AGENDA
CHASKA PLANNING COMMISSION
CHASKA CITY HALL - COUNCIL CHAMBERS & ZOOM
Wednesday, November 13, 2024
7:00 PM

REQUEST FOR ACTION

Subject: Rear Porch Addition — Variance Request to Deviate from the Rear Yard Setback (Section 15.12.200)

Case No.: 2024-19

Figure 2 (left): 2024 aerial map prior to porch conversion ; Figure 3 (right): survey showing porch layout

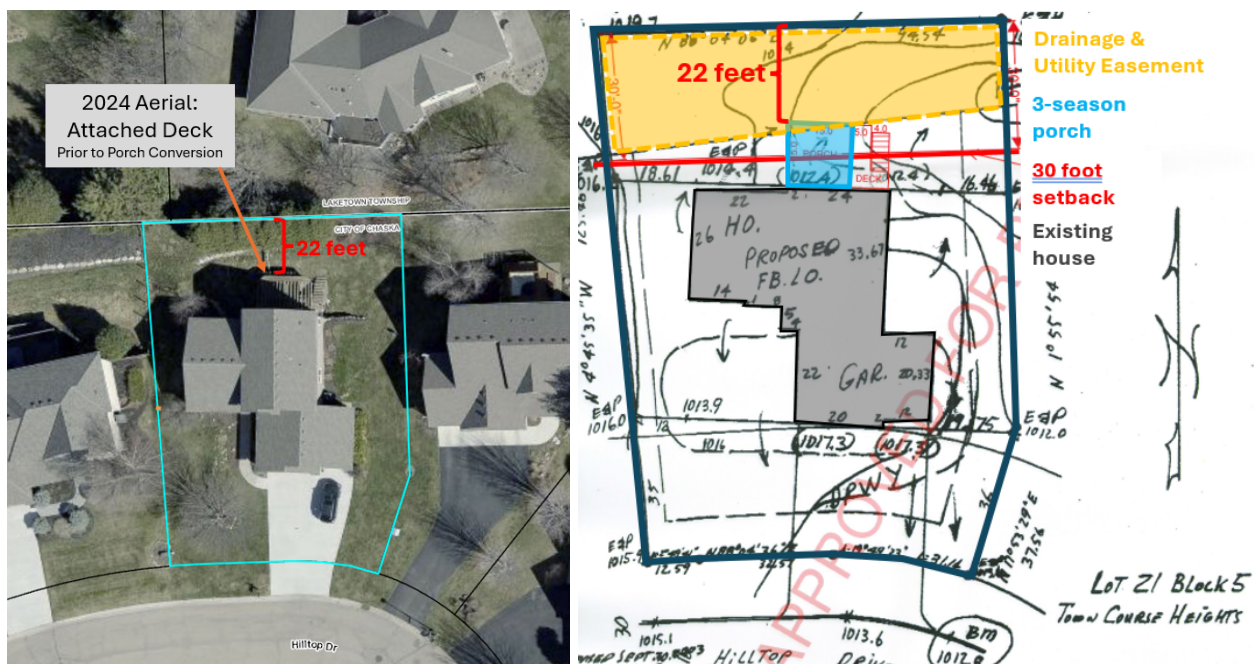
The 3-season porch was constructed in the summer of 2024 and did not receive a building permit. The location of the porch used to be an attached unenclosed deck, which was setback approximately 22 feet from rear property line (see Figure 2); *attached unenclosed decks have a 20 foot rear setback*. The 3-season porch was constructed over the former layout of the attached deck. The 3-season porch does not meet the rear yard building setback (30 feet). The 3-season porch is setback approximately 22 feet from the rear property line which is an 8 foot encroachment. A drainage and utility easement exists on the rear portion of the property and is depicted in Figure 3. The existing porch cantilevers up to 2 feet over this easement.

Figure 4: proposed, and existing, porch layout showing encroachment into 30-foot setback

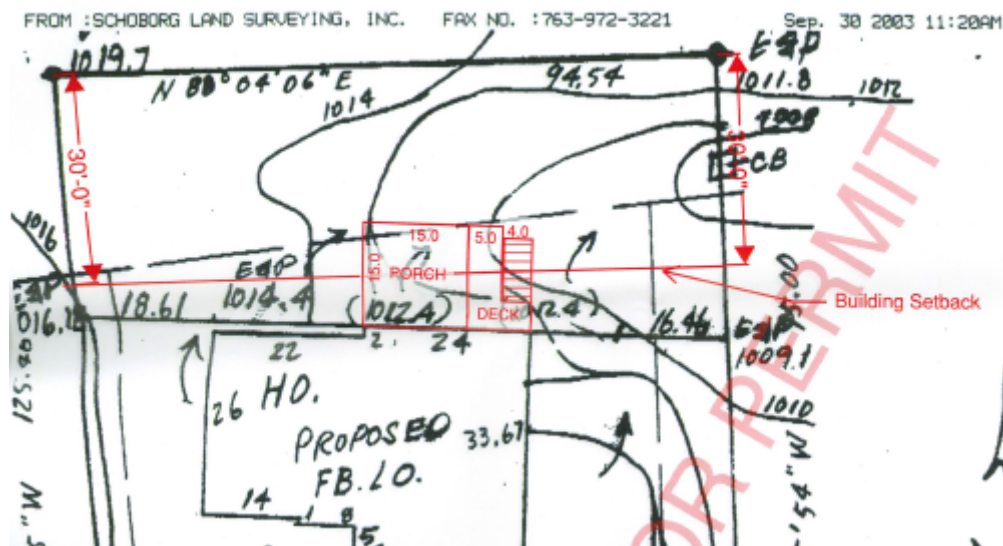
The applicant is proposing to keep a rear yard porch addition that encroaches into the rear yard building setback. As noted above, the porch addition was constructed in the summer of 2024 without a building permit. The porch addition shows a deviation of 8 feet into the rear yard setback (22 feet from rear property line).

As noted above, attached unenclosed decks can encroach into the rear building setback up to 10 feet in most zoning districts (section 15.12.200.J). In this instance the deck setback would be 20 feet from the rear property line. The conversion of the deck into an enclosed porch required that a 30 foot setback be met. Because the deck was already at 22 feet from the rear property line, it was not possible to convert the entire deck into an enclosed structure as it would not meet the 30 foot setback.

In staff's opinion the variance proposal is greater than necessary to accomplish the landowner's objective. The applicant is showing a porch addition that extends 15 feet off the back wall of the home, which encroaches approximately 8 feet into the rear yard setback. An alternative exists that allows a porch addition to extend approximately 7.5 feet off the back of the house while still meeting the rear yard setback.

Motion to recommend denial of the major variance request to encroach into the rear yard setback 8 feet for the purpose of an existing porch addition (Zoning Ordinance 15.12.200) that did not receive a building permit, to the City Council based on the following findings:

Figure 5: average acreages of detached single-family lots in Town Course Heights

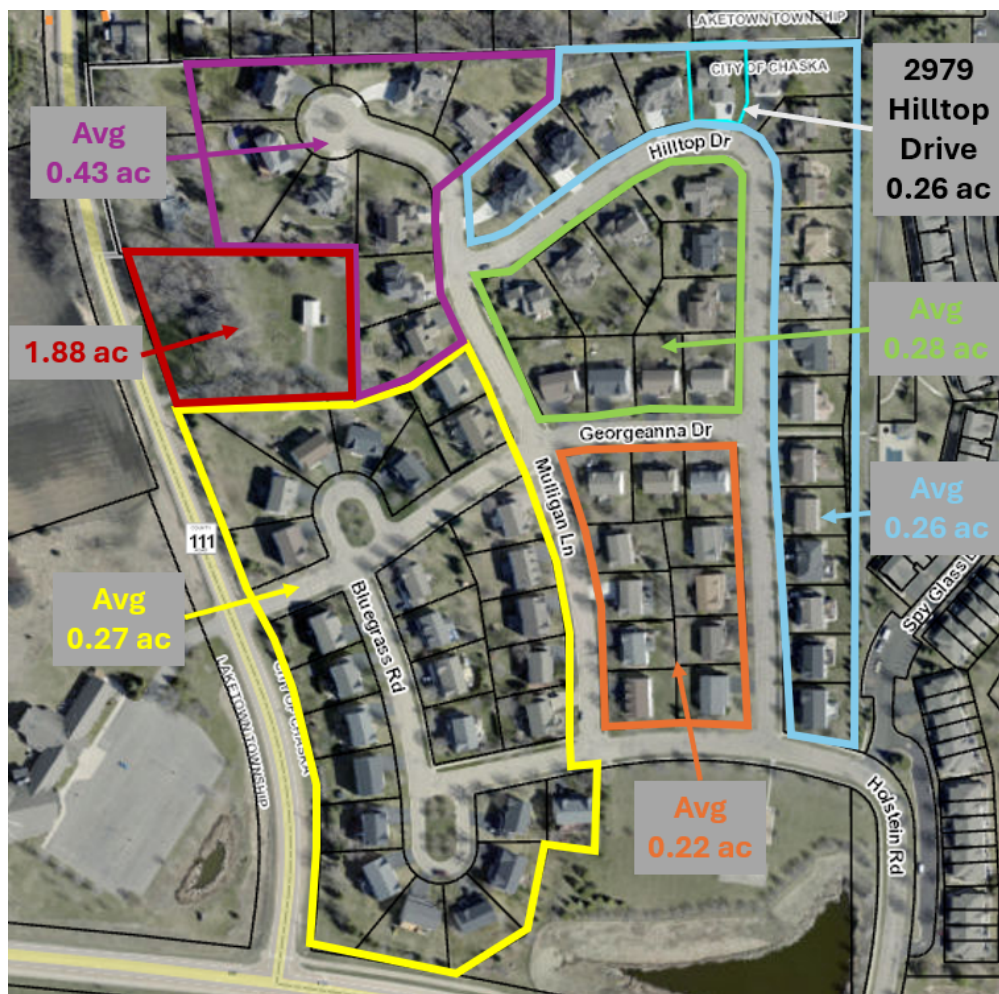
Unique circumstances do not appear to exist on the property. The property is a part of a subdivision (Town Course Heights) with similar sized lots and the same rear yard setback of 30 feet. The property is 0.26 acres in size and square in shape. The other detached single-family lots in the subdivision range from 0.20-1.88 acres in size with the majority averaging at 0.29 acres in size (see Figure 5). The lot is not uniquely smaller or shaped differently than the other lots in this subdivision. The lot also does not contain unique physical characteristics compared to other lots. The only unique characteristic worth noting is the presence of a drainage and utility easement on the rear portion of the property, however, this easement does not prohibit the property from building an addition (see Figure 3).
